# HISTORIC AND DESIGN REVIEW COMMISSION

May 15, 2019

**HDRC CASE NO:** 2019-240  
**ADDRESS:** 514 W CEVALLOS  
**LEGAL DESCRIPTION:** NCB 918 BLK LOT SE IRR 108.9 OF 19, NW IRR 45.7 OF NE 85 OF A-10 & PT OF D15  
**ZONING:** IDZ, RIO-7  
**CITY COUNCIL DIST.:** 1  
**APPLICANT:** Patrick Christensen  
**OWNER:** Muy Properties-CTW Limited  
**TYPE OF WORK:** Construction of a 1-story, commercial building  
**APPLICATION RECEIVED:** April 25, 2019  
**60-DAY REVIEW:** June 24, 2019  
**CASE MANAGER:** Edward Hall  
**REQUEST:**

The applicant is requesting conceptual approval to construct a 1-story, commercial structure at 514 W Cevallos, located within RIO-7.

SHEET NAME  
 EXTERIOR ELEVATIONS  
 SHEET NUMBER

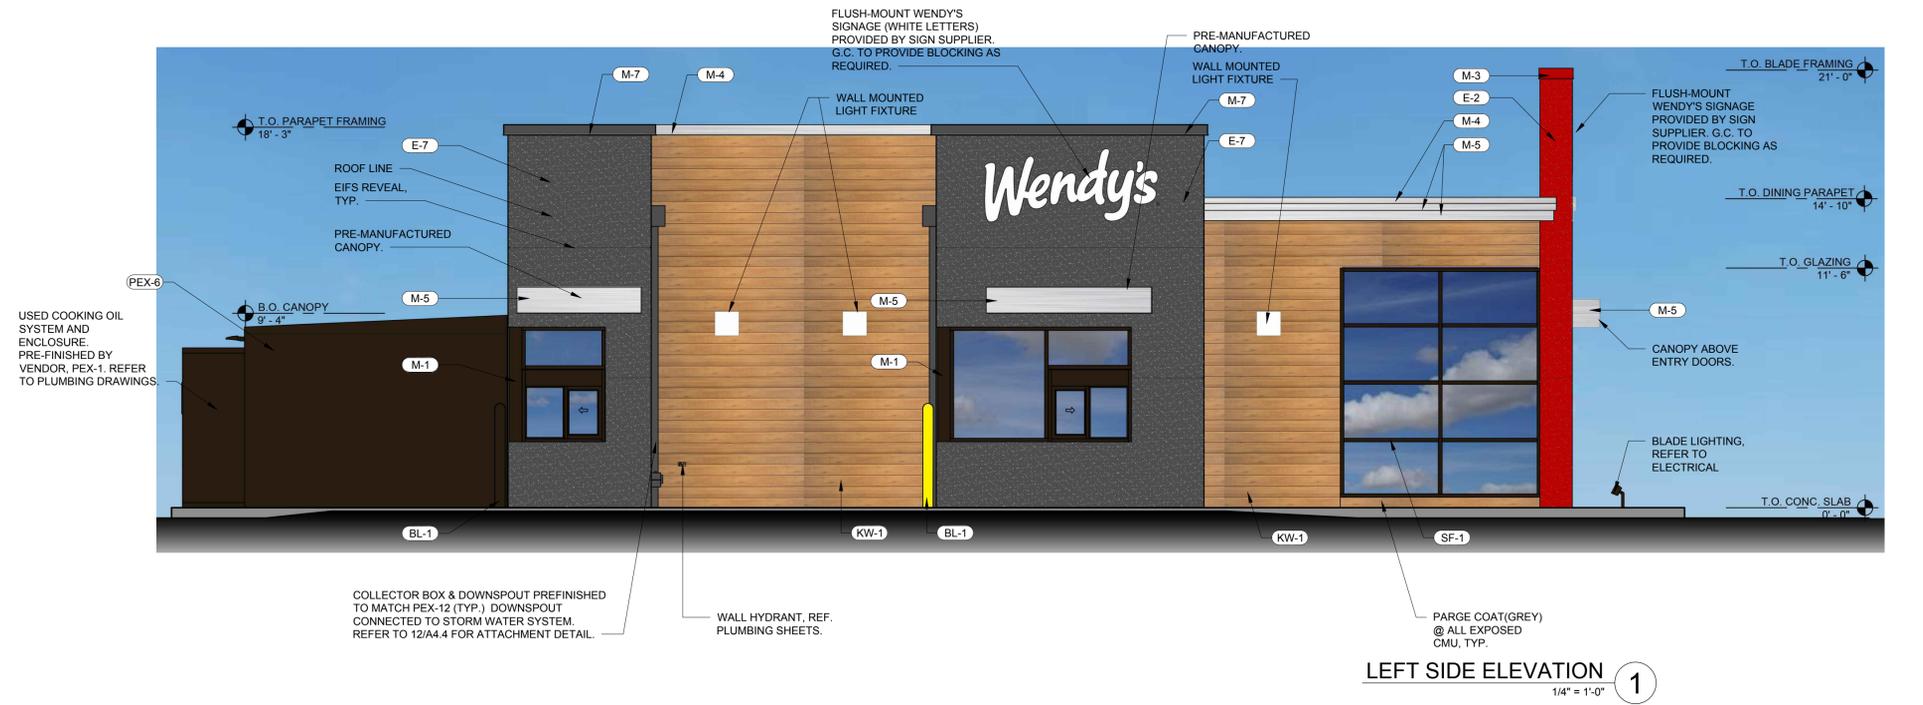
To comply with this, a building must (1) express façade components in ways that will help to establish building scale, (2) align horizontal building elements with others in the blockface to establish building scale, (3) express the distinction between upper and lower levels, (4) in this instance, divide the façade of the building into modules that express traditional and (5) organize the mass of a building to provide solar access to the river. The applicant has proposed a one-story structure which features human scaled elements, including a storefront system, entrance canopies, and human scaled façade openings. Staff finds the proposed building scale to be appropriate and consistent with the UDC.
